# UNITED STATES PATENT AND TRADEMARK OFFICE

APPLICATION NO.	FILING DATE	FIRST NAMED INVENTOR	ATTORNEY DOCKET NO.	CONFIRMATION NO.
10/810,660	03/29/2004	Wen-Jian Lin	QCO.091A/061121	1130
59747	7590	06/06/2006	EXAMINER	
KNOBBE, MARTENS, OLSON & BEAR, LLP			STARK, JARRETT J	
2040 MAIN STREET			ART UNIT	
FOURTEENTH FLOOR			PAPER NUMBER	
IRVINE, CA 92614			2823

# Office Action Summary

## **DETAILED ACTION**

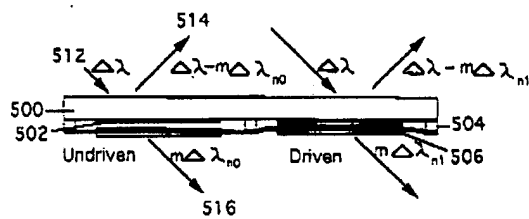
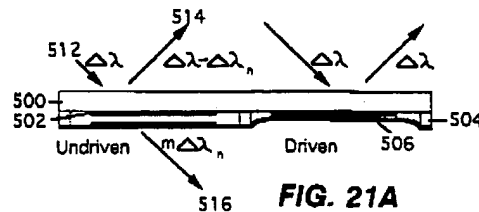
The applicant's representative argues that Miles (US 5,835,255) does not disclose partially reflective and transmissible electrodes. As shown in figure 21A Miles discloses that layer 500 is a transparent substrate (therefore negligible reflectance from substrate). The reflection and transmission lines 514 and 516 inherently show that first and second electrodes both are reflective and transmissive.

Also in regards to the argument to Miles not disclosing a material layer between the conductor layer and the first electrode. It is clearly depicted by Miles in Fig. 21 that membrane support layer (which is a material layer) is between a first and second electrode (502 & 506). This added limitation to the currently amended claims does not overcome the prior art as disclosed by Miles.

a first electrode that is partially transmissible and partially reflective; (Miles , Fig. 21A - [502], Fig. 27)

a second electrode that is reflective comprising: (Miles, Fig. 21A - [506], & Fig. 27)

a first material layer; and (Miles, Fig. 2A – see response to argument above)  
a conductor layer set on the first material layer and approximately in parallel to the first electrode wherein the first material layer is positioned between the conductor layer and the first electrode; and (Miles, Fig. 21A - [502])

a supporter configured to separate the first electrode and the first material layer to form a cavity; (Miles, Fig. 21A - [504])

(Miles, Col. 20 lines 55-57 → 900 is symbolizes both the support membrane & conductor/electrode [506] and the substrate [500] & conductor/electrode shown in Fig. 21)

*FIG. 41* PRIOR ART

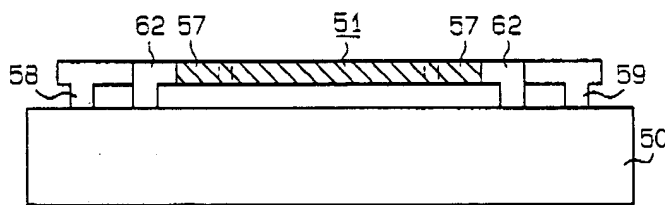
Gotoh discloses wherein the silicon material is poly-silicon.

At the time of the invention, it would have been obvious to a person of ordinary skill in the art to use polysilicon as a support membrane.

*A movable portion 51 of a beam structure is disposed above a silicon substrate 50 with a prescribed gap therebetween. The movable portion 51 of a polysilicon thin film comprises beam portions 52, 53, 54 and 55, weight portion 56 and movable electrode portions 57. (Gotoh, Col. 1, lines 32-37)*
